# Lexington High School

## Educational Planning & Equity Focus Group

03/12/2025

## Travel Times

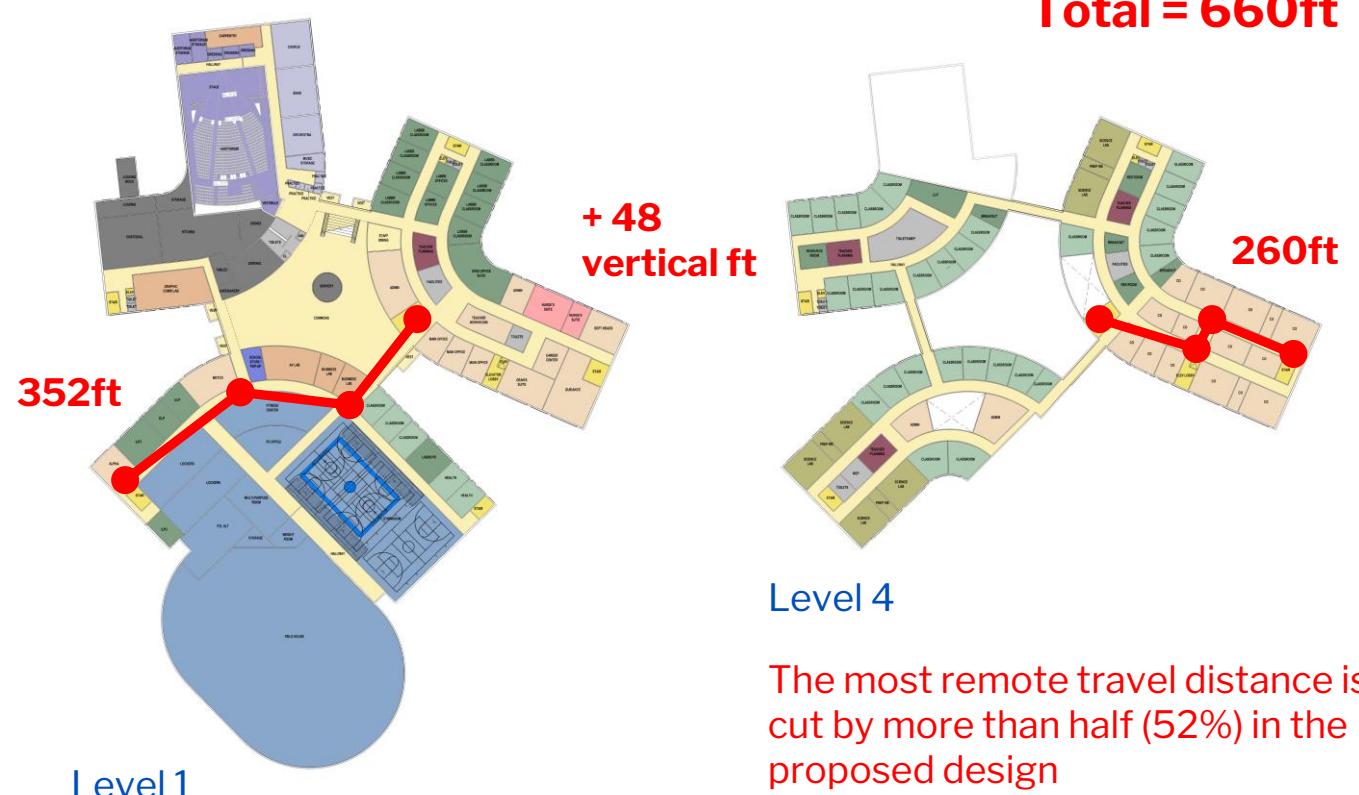
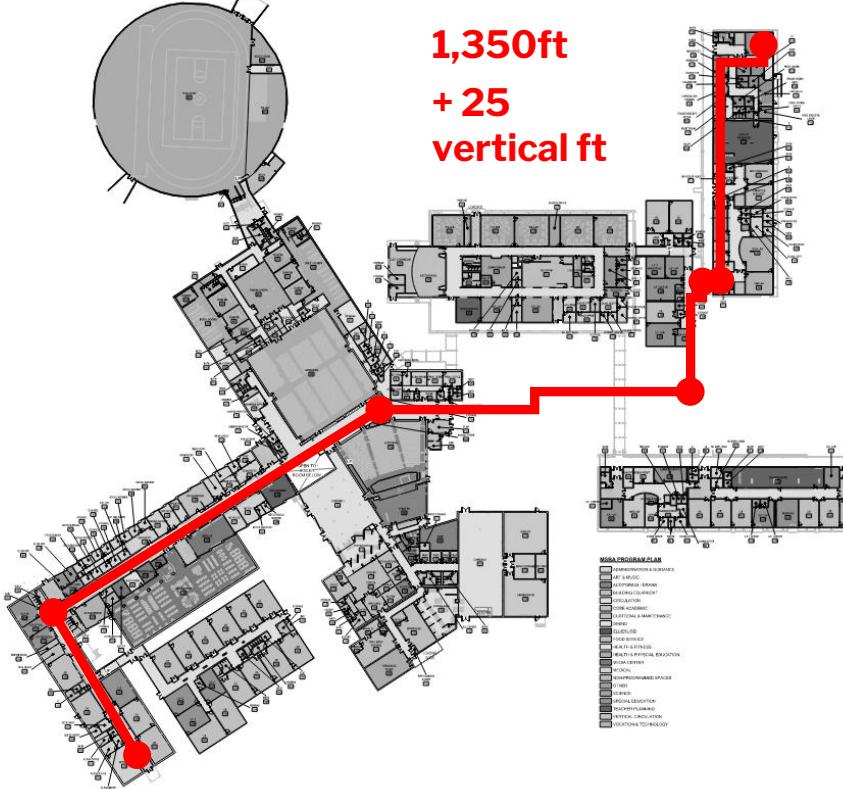
**EPE 33:** Transition time is not sufficient to get from class to class

**EPE 34:** New building has to factor in traffic and transition time

- Student travel times are considered throughout the design process. Potential outcomes of this study may include both spatial as well as schedule accommodations.

Design team has studied travel times of both the existing school and the proposed design.

### Existing Travel Time (Level 2 Building A to Level 2 Building J)

= **5.5 minutes** at an average adult walking speed

= **7 minutes** at a slower pace simulating an overcrowded condition between classes

### Proposed Building Travel Time (Level 1 C Wing to Level 4 B Wing)

= **3.5 minutes** at an average adult walking speed

The most remote travel distance is cut by more than half (52%) in the proposed design

## Topics Needing Further Discussion/ Multi-User Toilet Room Designs

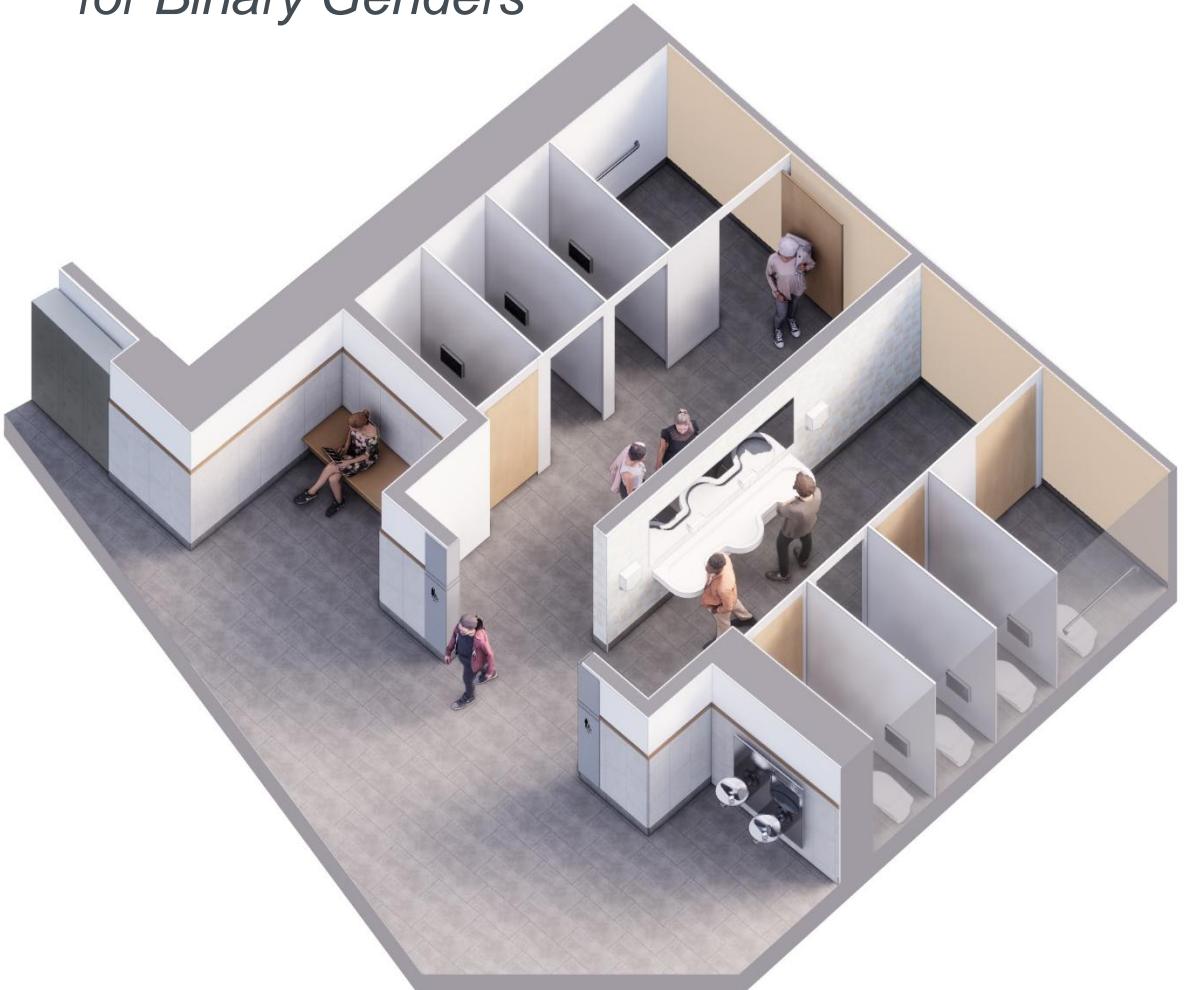
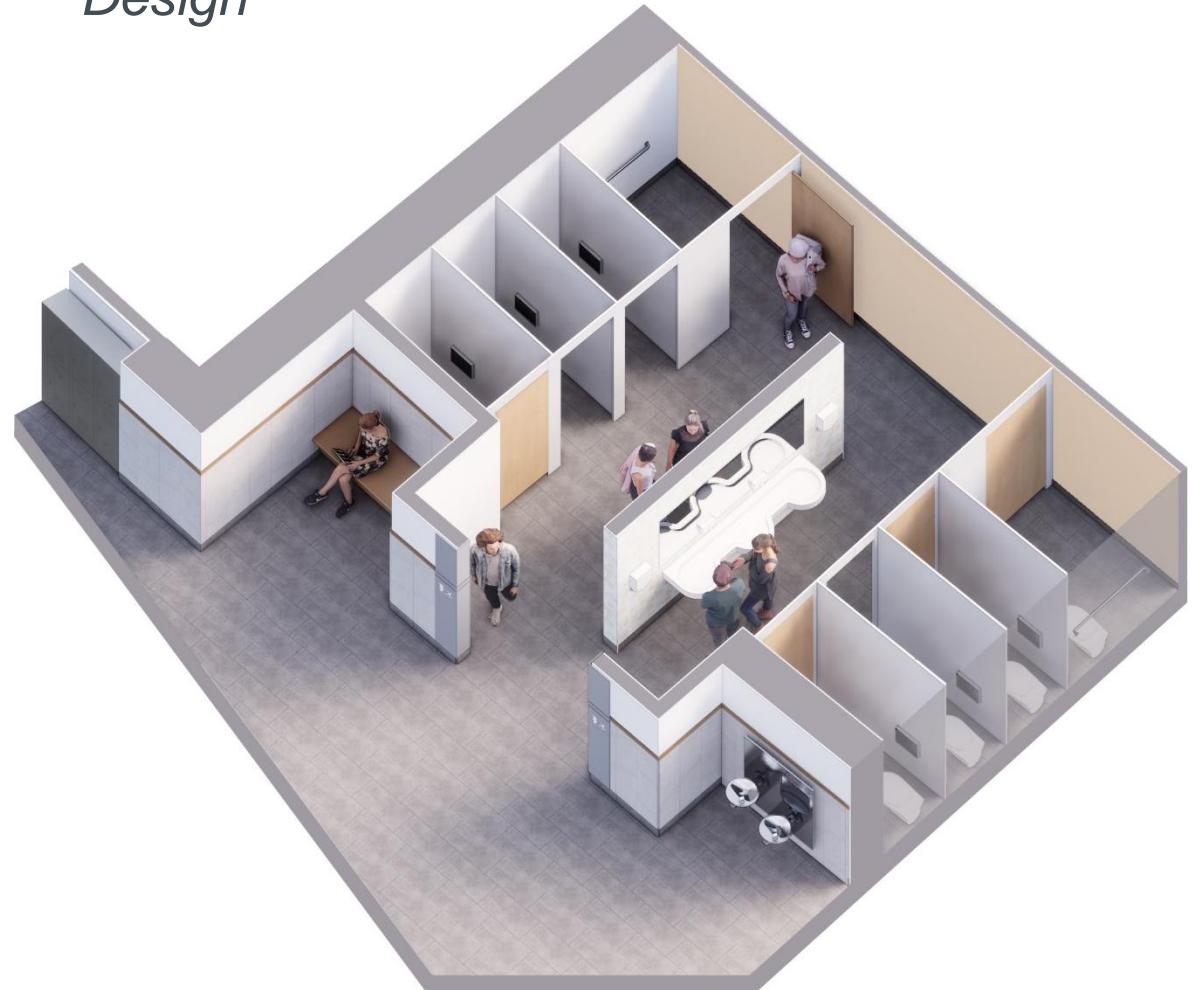
### EPE 59: Need more gender-neutral bathrooms, conveniently located

### EPE 60: Have to be careful/plan for people of different cultural backgrounds

- Recommendation is to provide a mix of all-gender and traditional binary gendered multi-user toilet rooms throughout the new school – the extent and locations of different types of restrooms will be studied at a later stage of design.

- Recommendation is to provide some gendered toilet rooms throughout the building for those who would feel uncomfortable using all-gender restrooms. Further discussion with students and educators is needed.

Design team is examining the distribution of all-gender/non-gendered multi-user restrooms, gendered single-user restrooms, and the potential inclusion of gendered multi-user restrooms near public-facing program (e.g.: gymnasium, Auditorium)

## Lockers

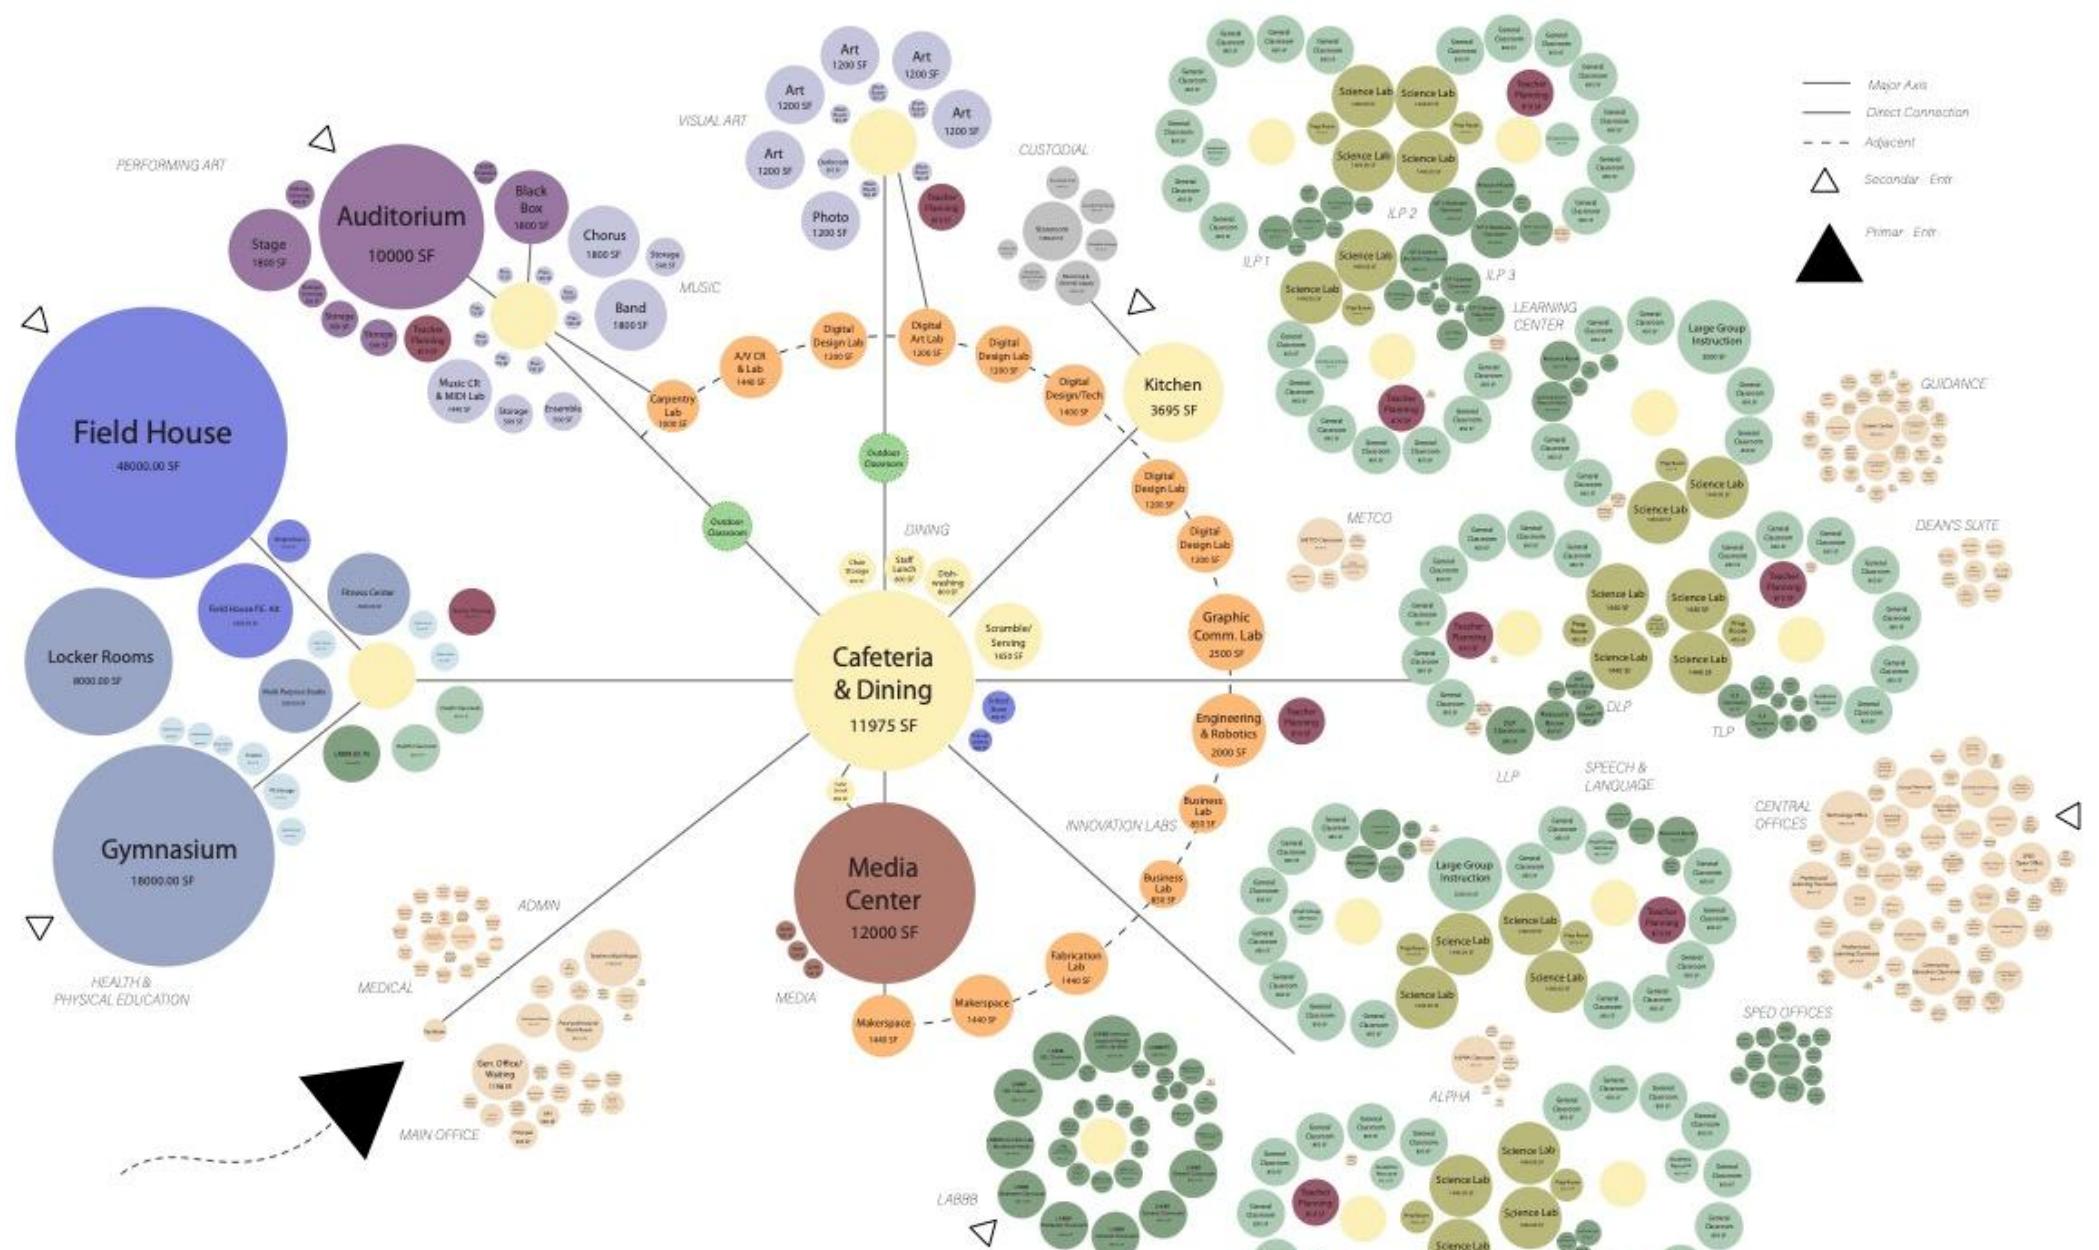
### EPE 71: Lockers are underutilized

### EPE 72: Shared-use lockers are great for optimizing space

- This will be part of further discussion with students and administration. Typically, lockers are provided for some percentage of the student enrollment. Any lockers provided will be sized appropriately to maximize usefulness.

- This will be considered. SMMA has implemented a shared-use locker system in other schools, where lockers are used on an “as-need” basis.

Design team is carrying 650 lockers for general use (Music and Athletic locker quantities are separate).

Shared short-term locker use is being considered. Locker sizes are to be determined, but team and administration are considering various sizes.

## Option B / Renovation + Addition

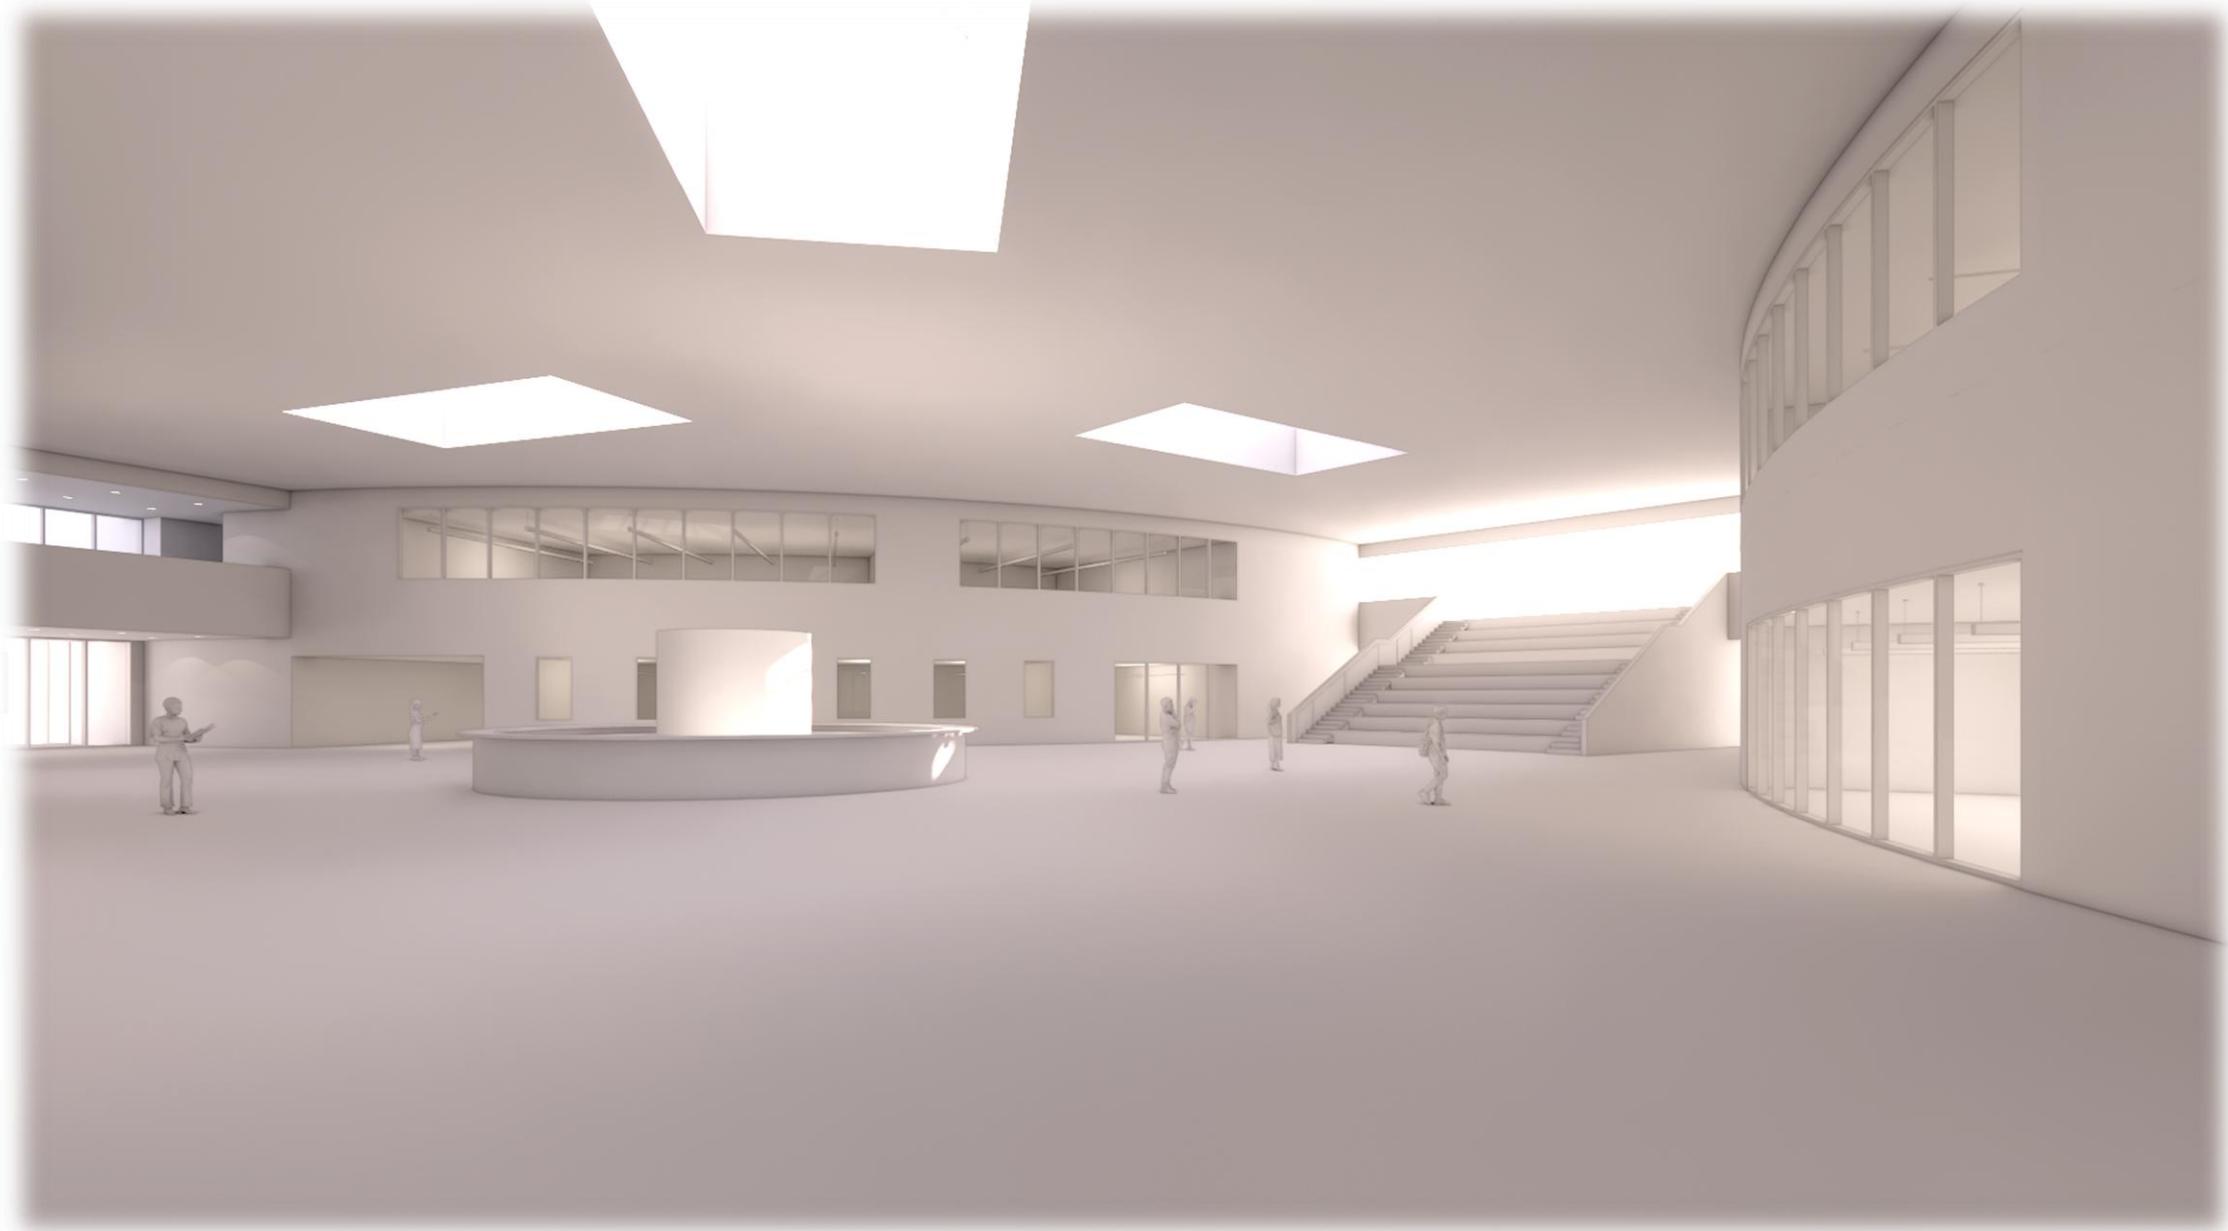
### EPE 56: Needs to be a larger conversation surrounding both the Pool and Field House

A pool will not be a part of the project. The SBC voted to do a renovation and addition to the existing Field House. The design team has been having discussions with educators, Athletics, and the Recreation Department to refine the programmatic elements and layouts.

1. Minimum safe run-out length to be determined. Drawing shows only 13' with 55m straight track\*
2. 3 courts possible if overlapping track and portable long jump pit
3. Increased PE Alt. size from 3,300 sf existing
4. Increased Weight room size from 679 sf existing
5. Existing roof structure does not allow for goals, wrestling mats, batting cage, etc. to be hung from rafters
